VSI Discovery and Configuration Protocol (VDP)

*Proposed Resolutions to subset of comments against
802.1Qbg Draft-1*

*Version 01
07/12/2010*

VSI State Machine – Station

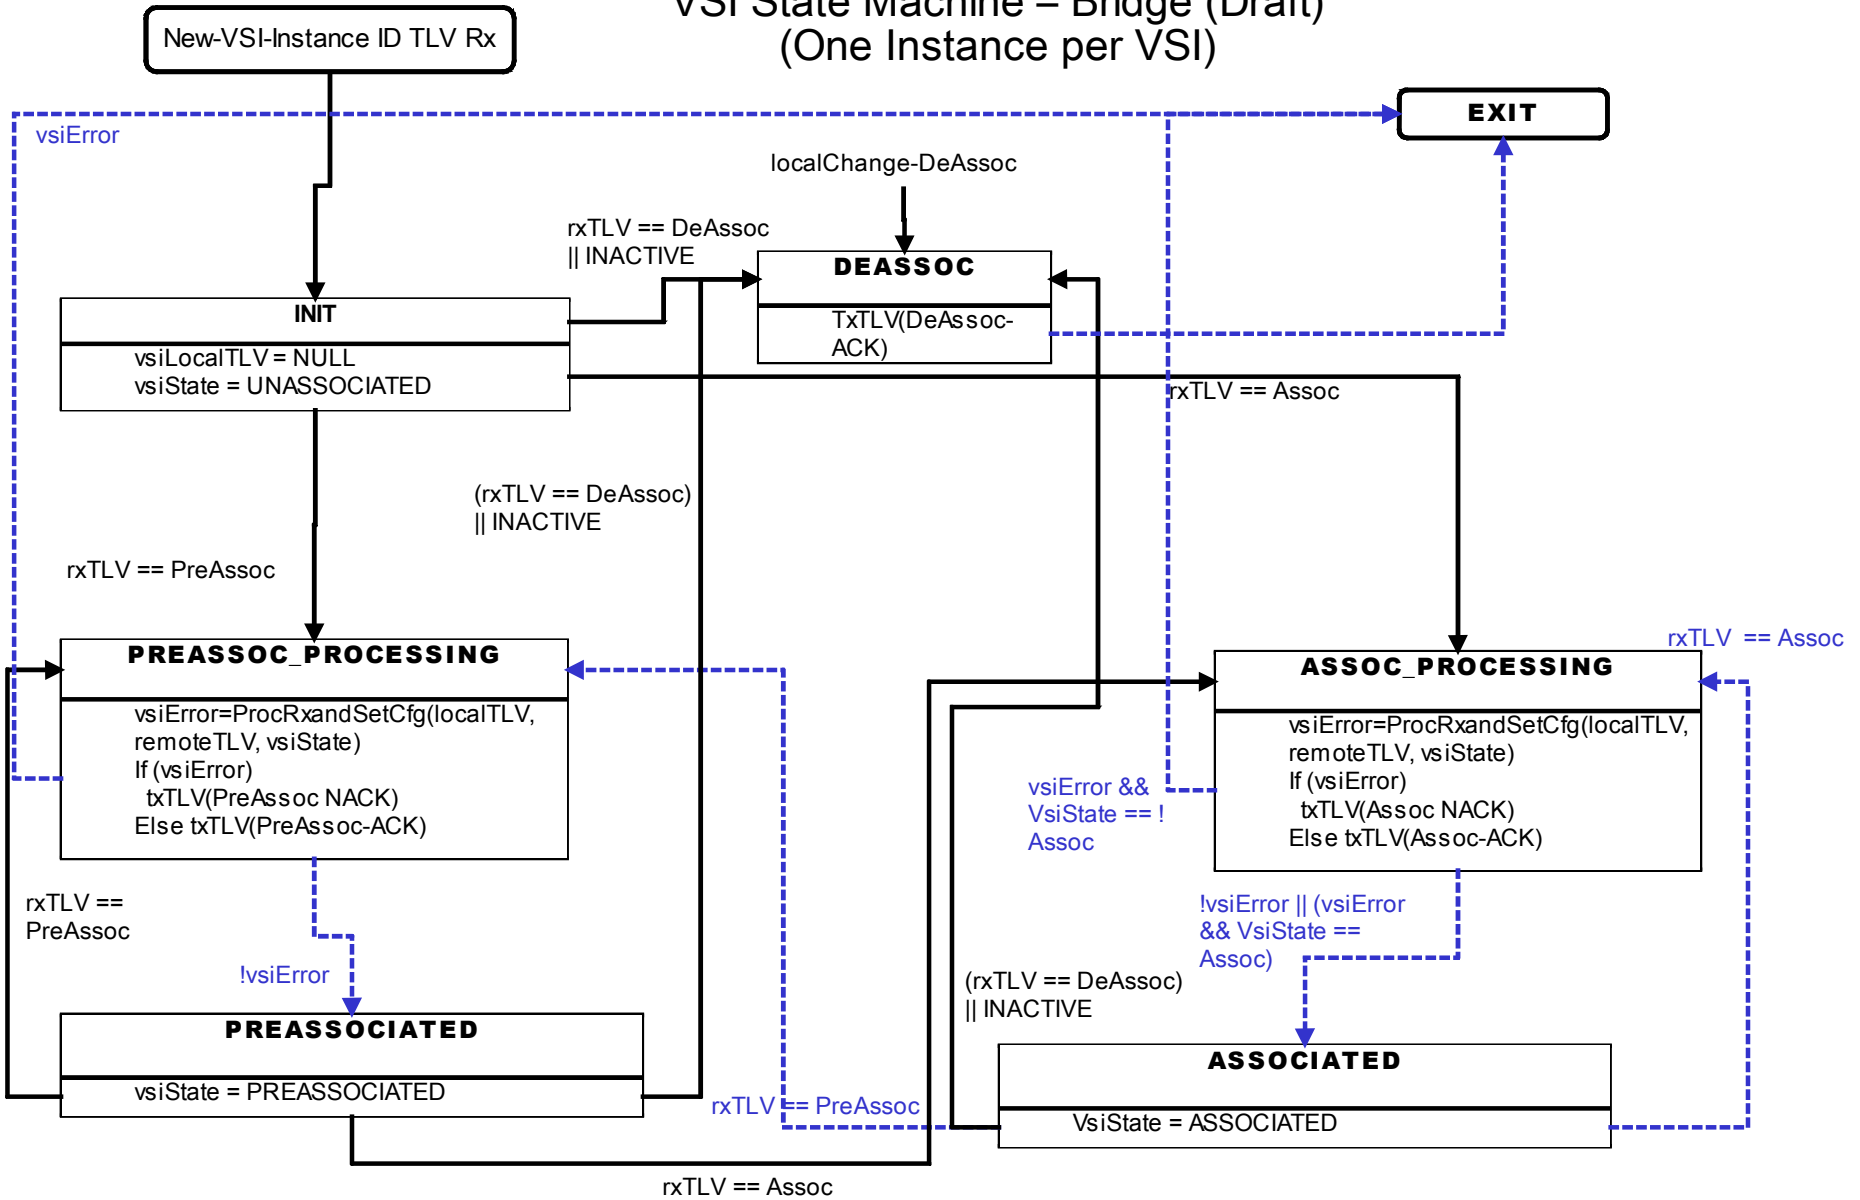
- ***Originator's Description:***

- Current Station state machine uses two timers for an response timeout and for a keep alive.
- Current Bridge state machine uses one timer for a keep alive time out.
 - Change Station to count down timers
 - Change Bridge to count down timers

- ***Resolution Proposal:***

- Can be an update to existing machine (IEEE 802.1Qbg Draft-1) if recommended by TG.

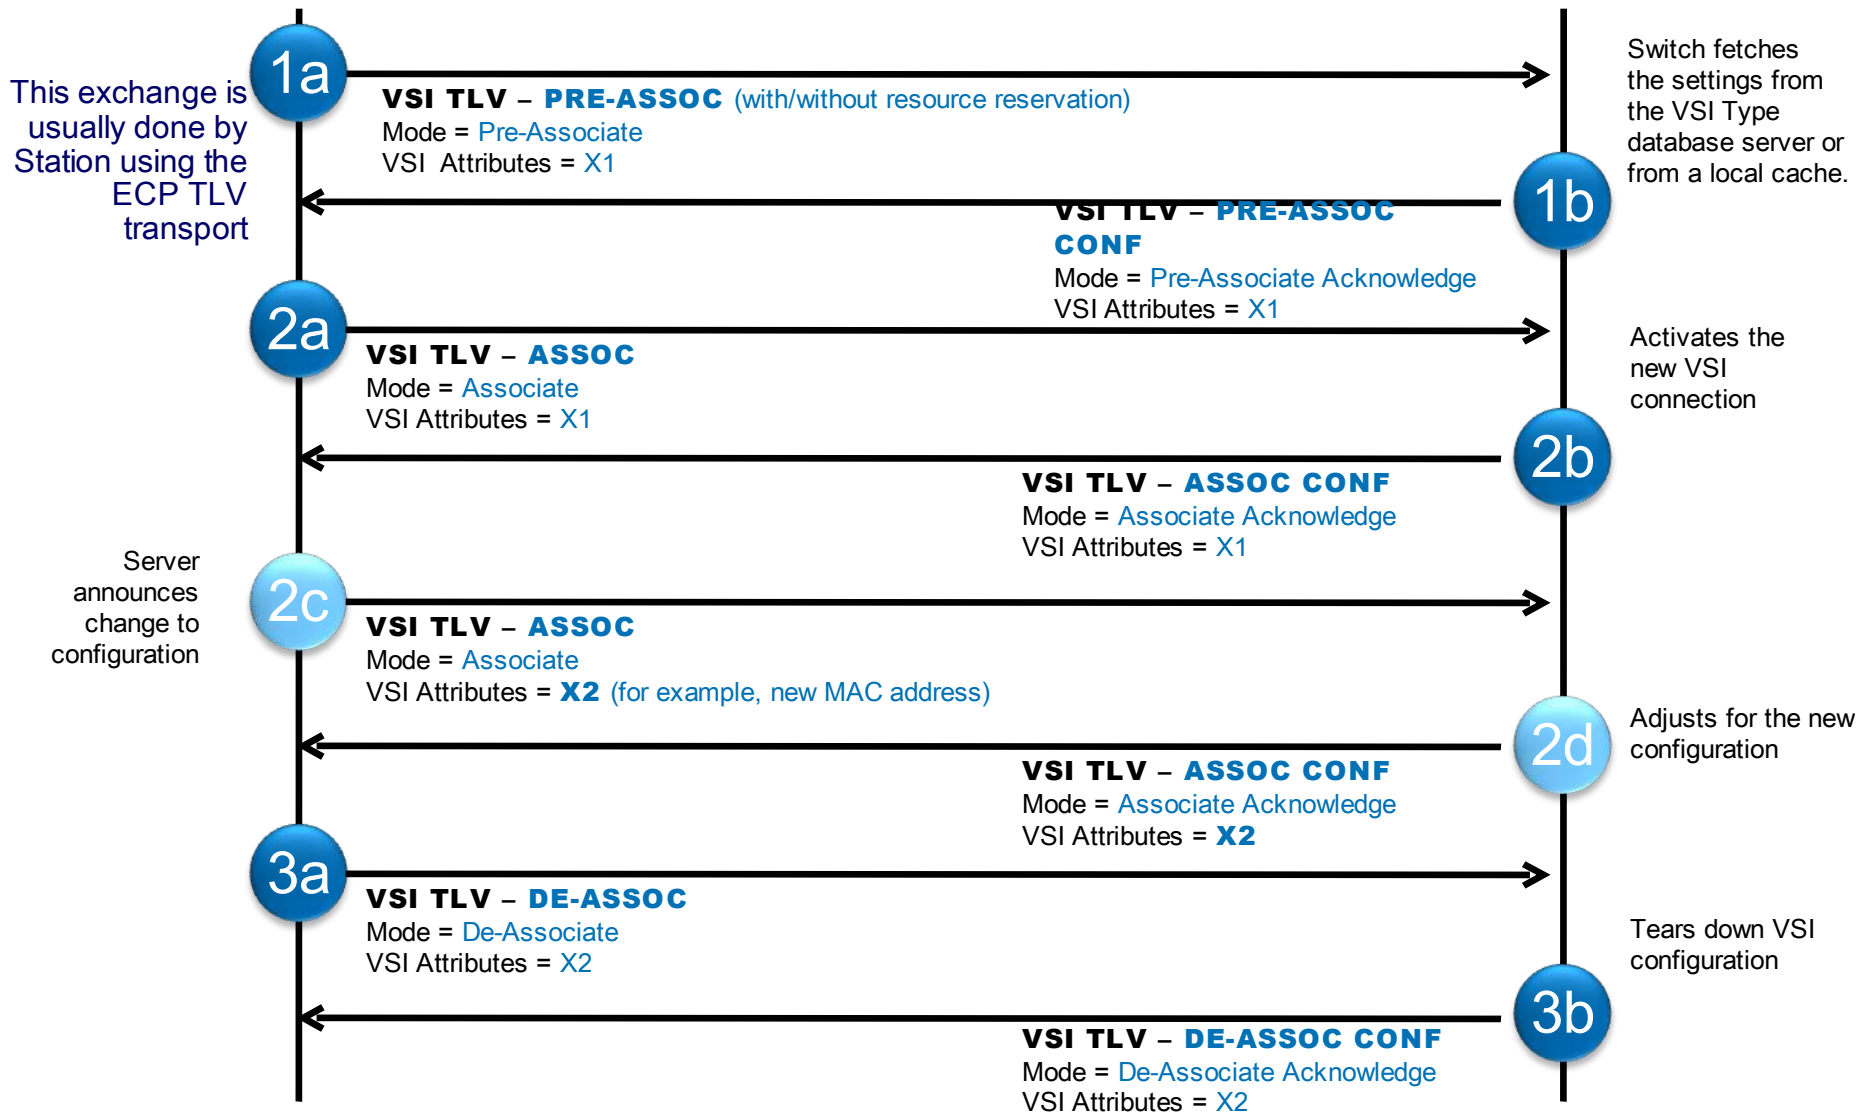
- ***Originator's Description:***

- No KEEP ALIVES during preassociate

- ***Resolution Proposal:***

- This is not true. The version 0 state machine does have a Keep Alive during pre-associate, it's the ACTIVITY_TIMER_EVENT. When the Activity Timer pops, the state machine transitions from Pre-Associated to Pre-Associate processing, which results in resending the last Pre-Associate.
